Addendum 1
File 19-99643
Stone Materials for Canal Park Storm Damage Repair

This addendum serves to notify all bidders of the following changes to the solicitation documents:

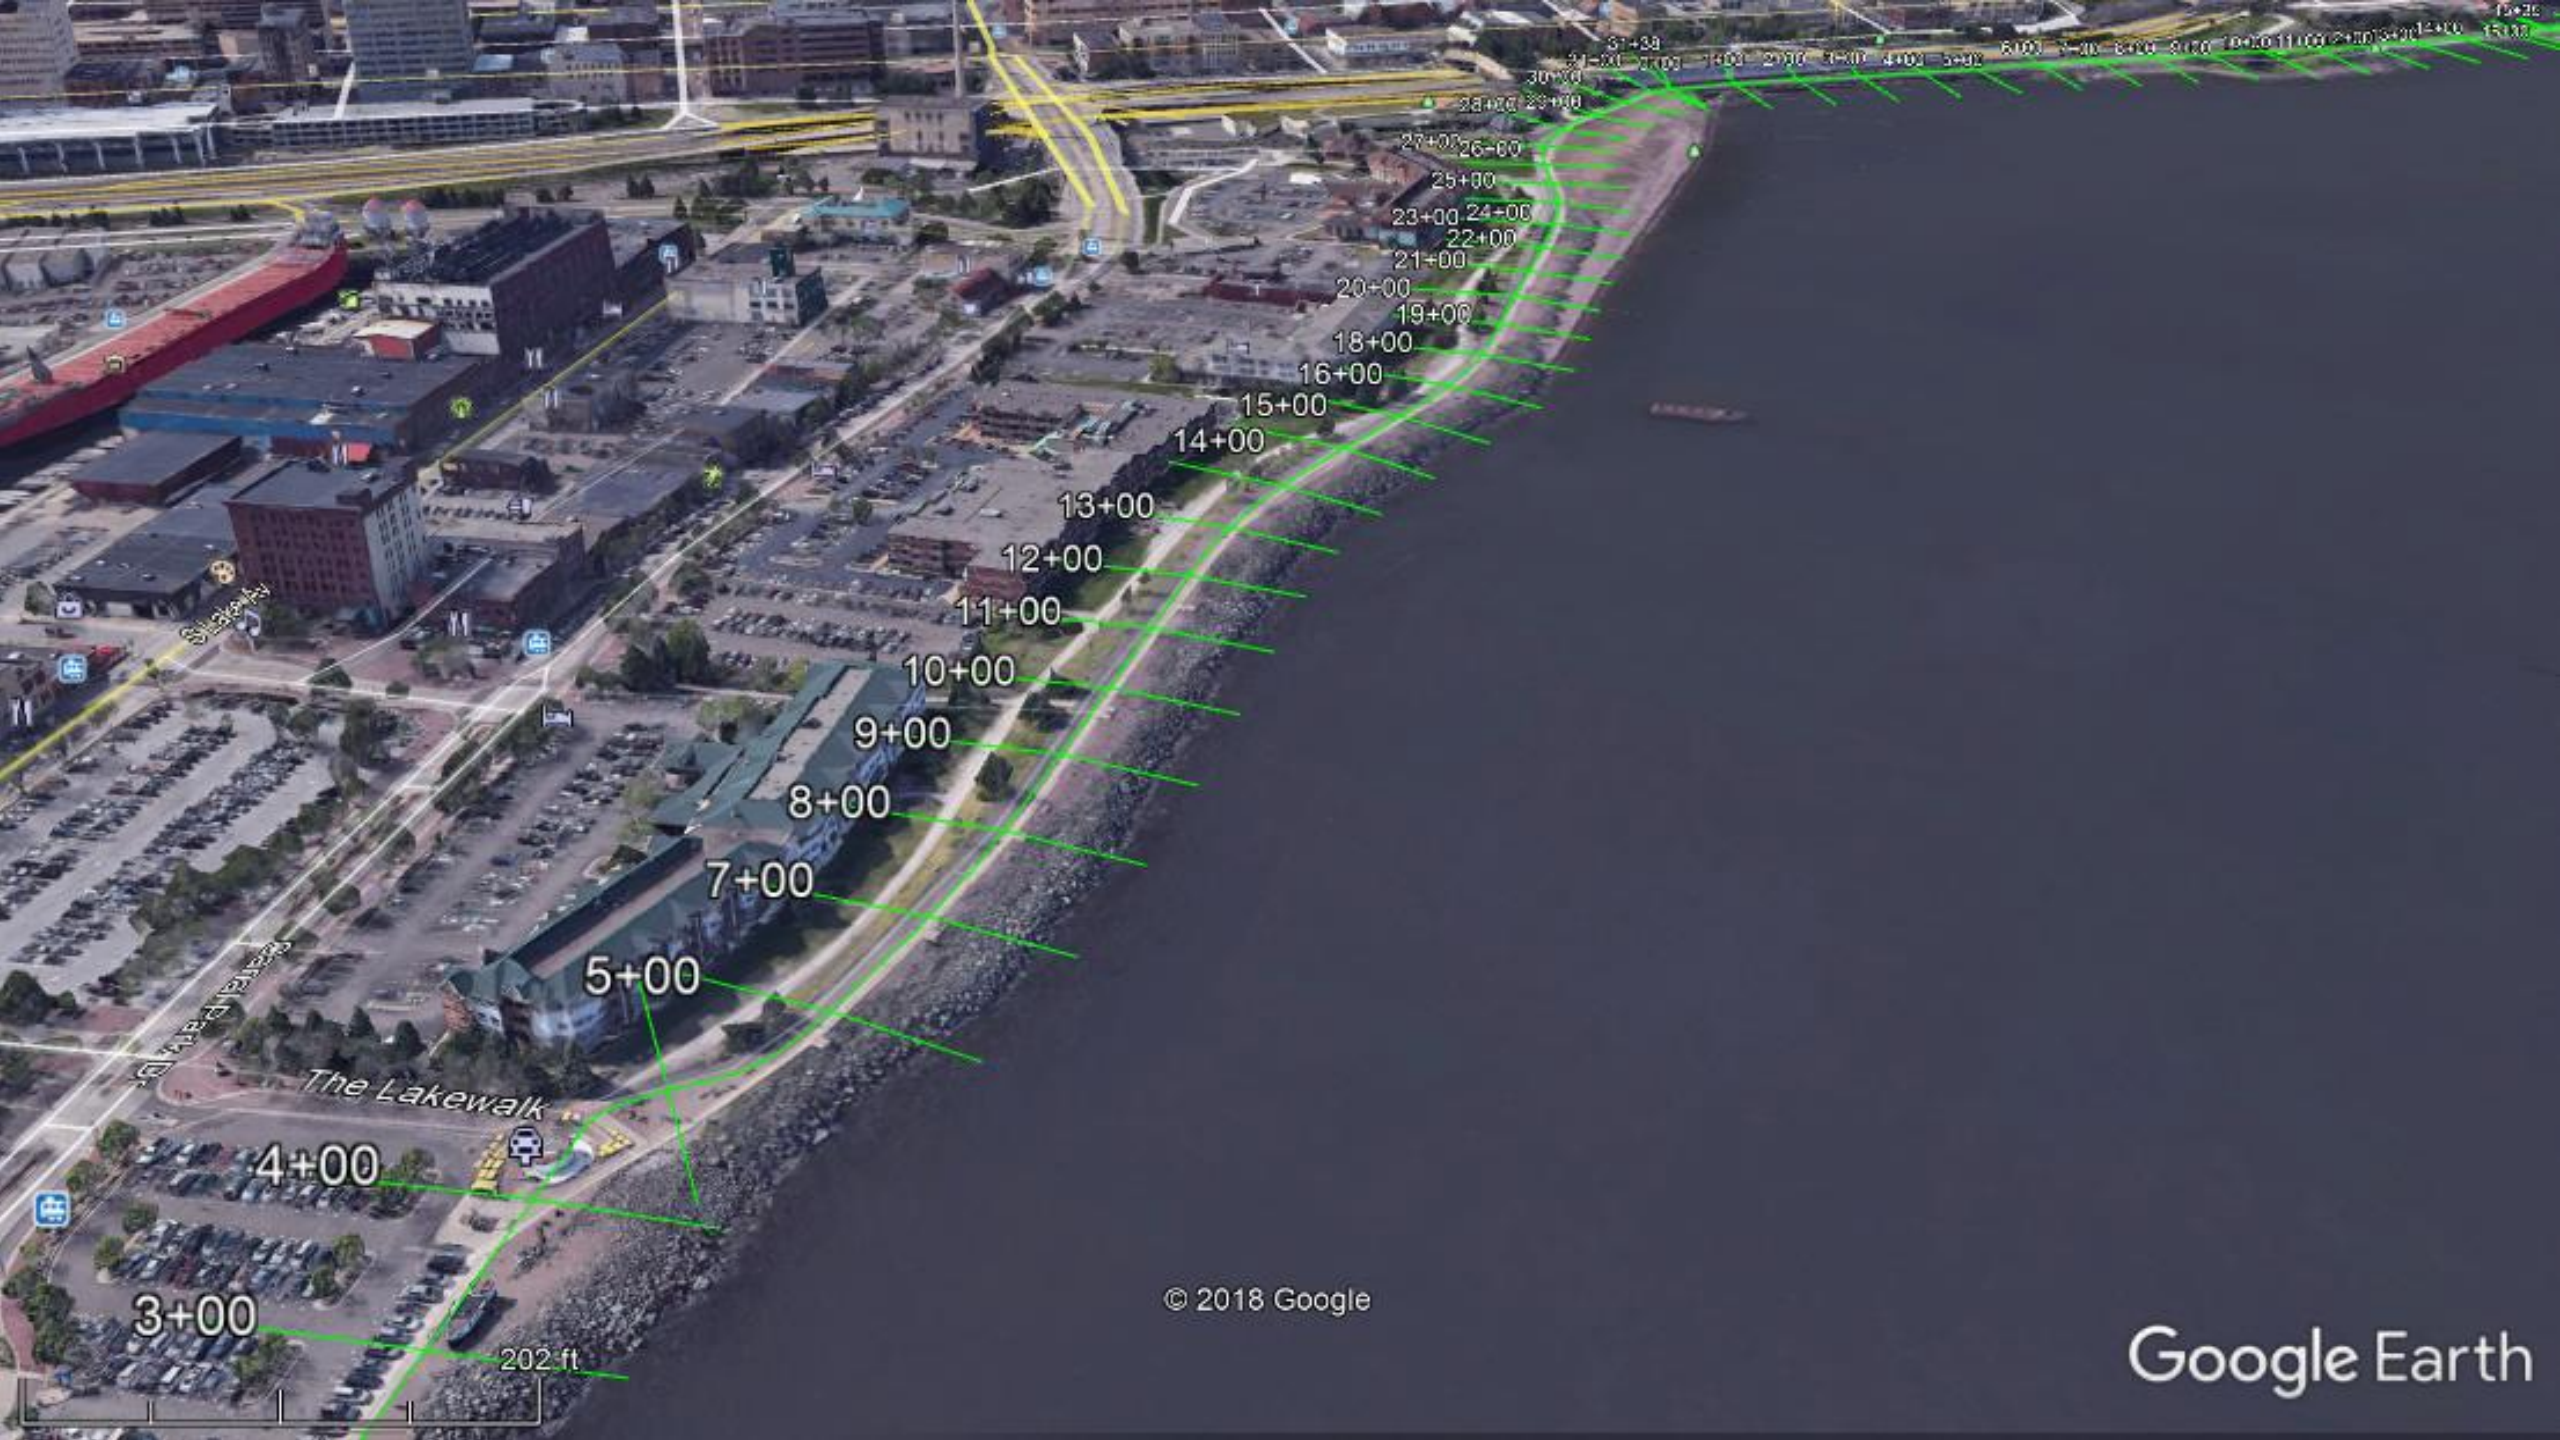
3. What is the work area and what is the storage area?
 - a. The work area is the entire length of Canal Park (Sta 1+00 to Sta 24+00), see attached GoogleEarth map. The storage area is the area depicted in the 'Site Access & Stone Storage' plan.
